August 11, 2005
LIC-05-0083

**SUBJECT: Fort Calhoun Station Unit No. 1 License Amendment Request (LAR),
"Tri-sodium Phosphate Volume"**

Omaha Public Power District's Evaluation
for
Amendment of Operating License

Figure 2-3

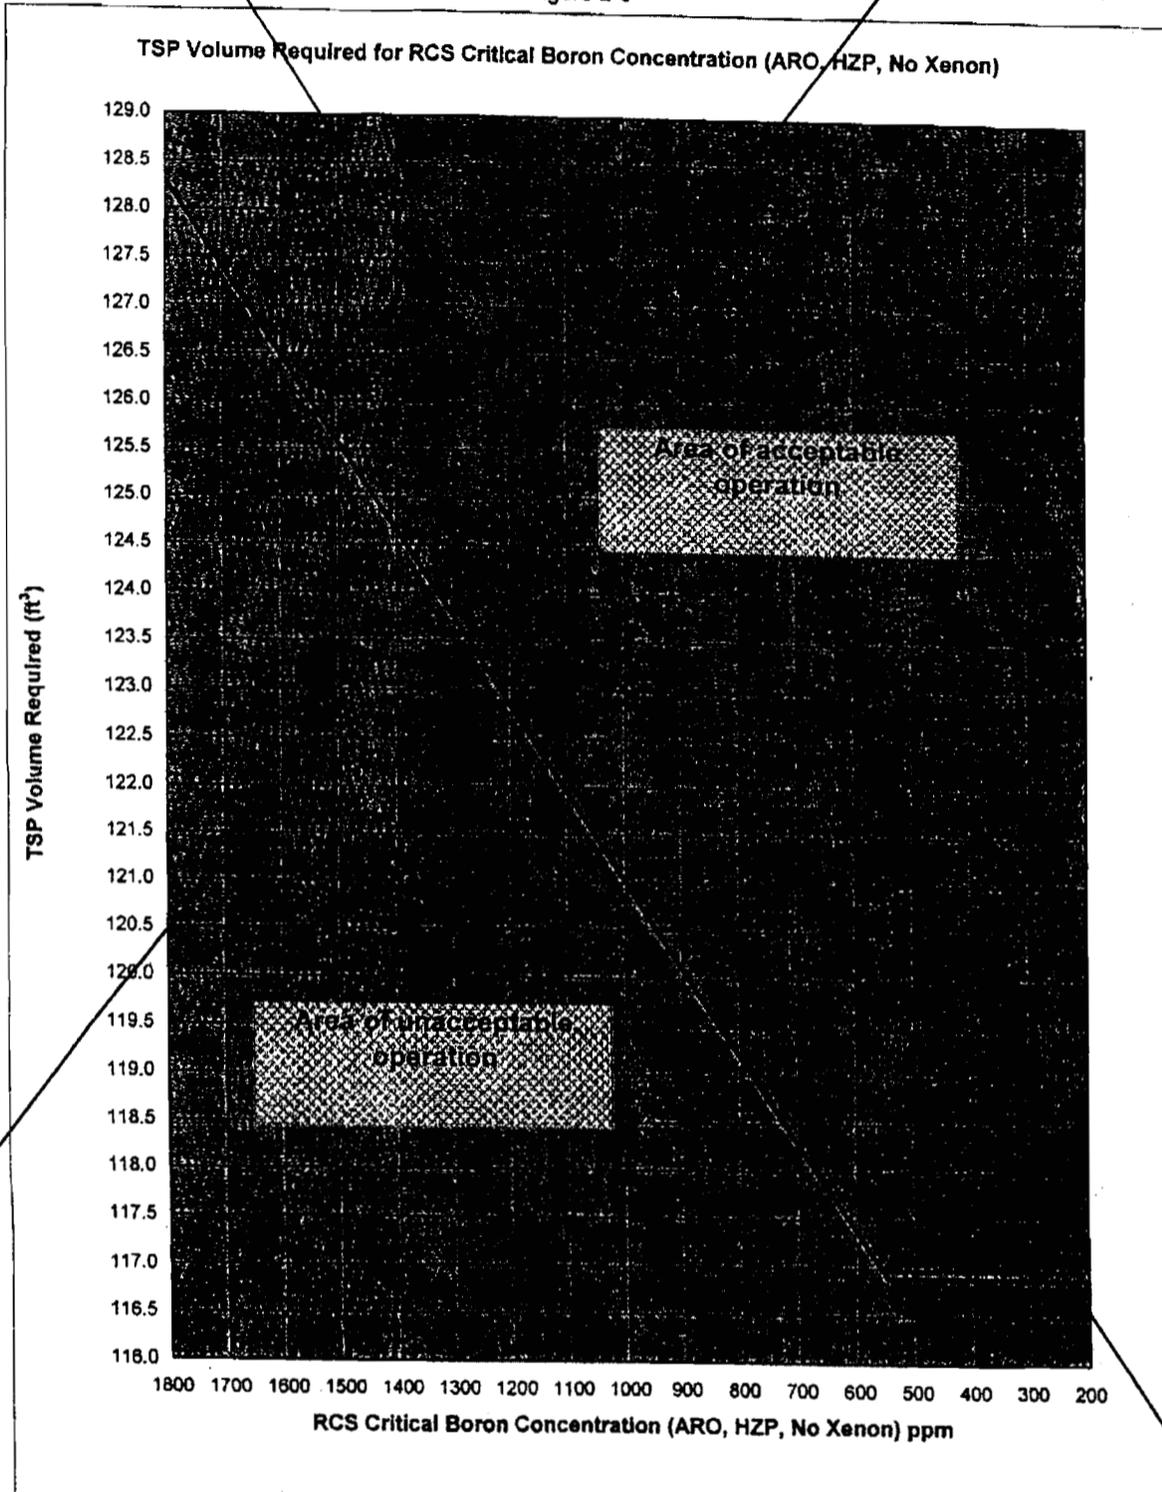
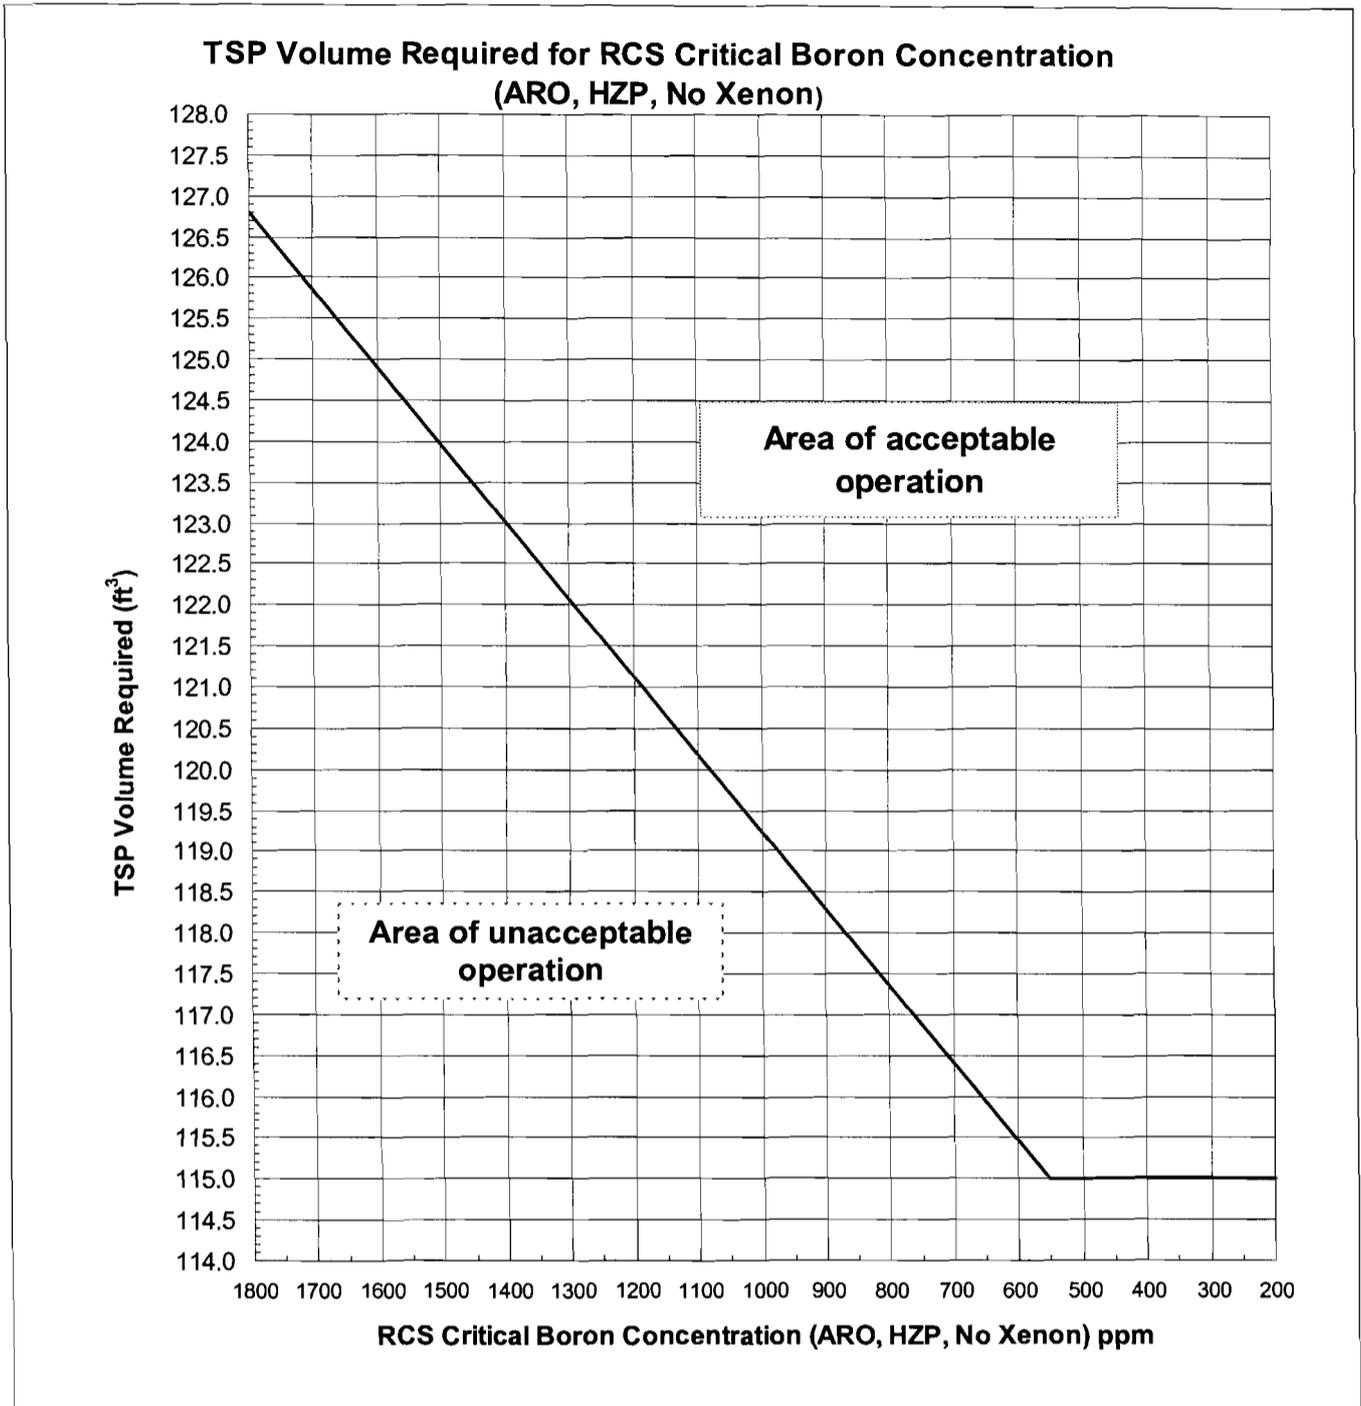
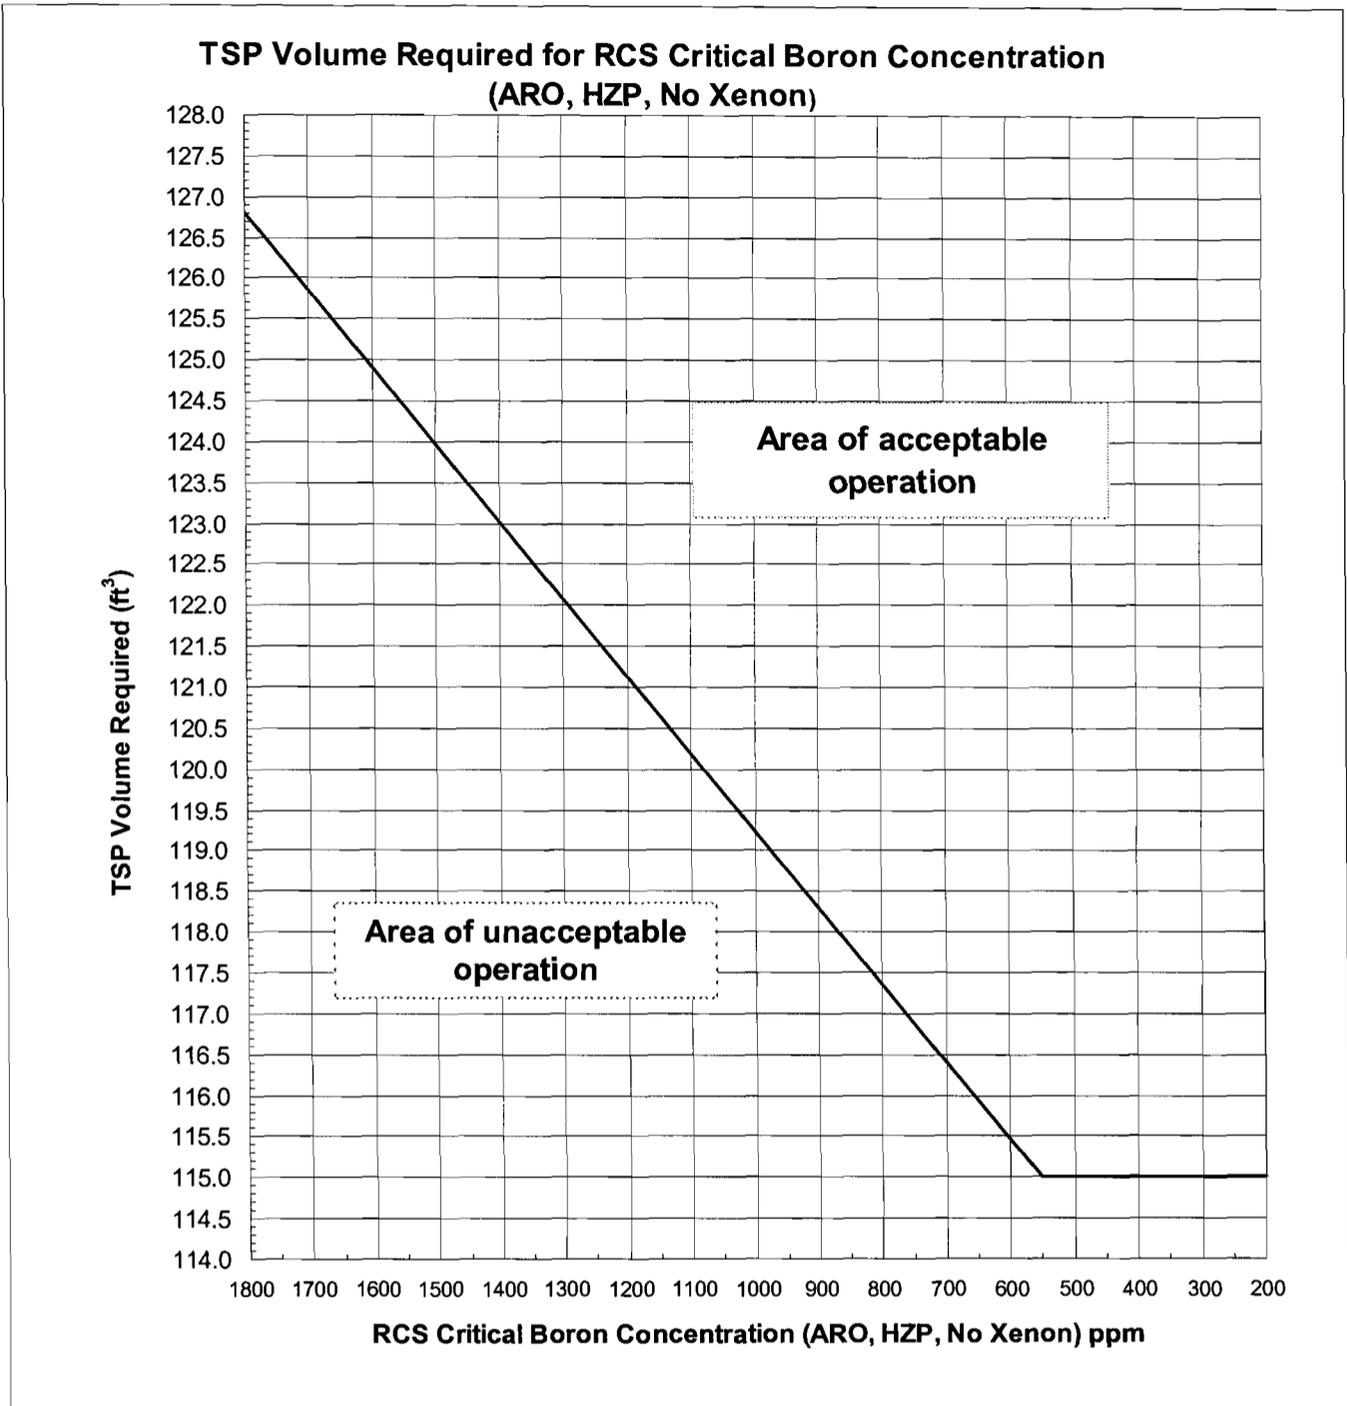
OPPD proposes to revise Figure 2-3 in Technical Specification (TS) 2.3(4) and related technical information to this figure in the Basis of TS 3.6. This figure shows the minimum volume of Tri-sodium Phosphate (TSP) required for a specified reactor coolant system (RCS) hot zero power (HZP) critical boron concentration (CBC) over the operating cycle. Maintaining a volume of TSP in the baskets that is within the area of acceptable operation of Figure 2-3 ensures that the recirculation water in the containment sump attains a pH of 7.0 or greater following a loss-of-coolant accident (LOCA). This figure allows the required volume of TSP to gradually decrease as HZP CBC decreases during the operating cycle. As HZP CBC decreases, less TSP is required to attain a pH of 7.0 or greater in the containment sump. Also, TS 3.6(2) is being revised to remove the term Dodecahydrate to be consistent with FCS TS Amendment No. 232 (TAC No. MC3214)

The proposed revision to Figure 2-3 shows the same downward trend in TSP requirement but with revised endpoints. The figure is being revised to account for the change in RCS volume due to the replacement of major components and due to removing excessive conservatism in accounting for radiolysis products. At an RCS HZP CBC of 1800 ppm, 126.8 ft³ of TSP is required. RCS HZP CBC in the range of 550 ppm to 200 ppm requires 115.0 ft³ of TSP. The TSP requirements outlined in this figure bound expected HZP CBC for any operating cycle. This proposed revision to Figure 2-3 utilizes the same methodology established in Amendment 232 (Reference 7.7). Also, TS 3.6(2) is being revised to remove the term Dodecahydrate to be consistent with FCS TS Amendment No. 232 (TAC No. MC3214).

The proposed amendment to TS 2.3(4) revises the graph shown in Figure 2-3 to show a new minimum required volume of TSP versus HZP CBC over the operating cycle. This revised figure has a minimum required TSP volume of 126.8 ft³ at the beginning of cycle (BOC) and a minimum required TSP volume of 115.0 ft³ at the end of cycle (EOC). Based on historical data, the BOC HZP CBC is bounded by 1800 ppm, and EOC is bounded by 550 ppm. The EOC HZP CBC could be less than 550 ppm, so the curve is extended as a horizontal line at this point.

Figure 2-3 of TS 2.3 is revised to show the new areas of acceptable and unacceptable operation for the volume of TSP required over the operating cycle versus HZP CBC. The Basis of TS 3.6 is revised to update the TSP volume requirements, the sump volume, the sump boron concentration, and the engineering analysis reference. TS 3.6(2) is revised to remove the term Dodecahydrate to be consistent with FCS TS Amendment No. 232 (TAC No. MC3214).

Replace with new
Figure 2-3

New Figure
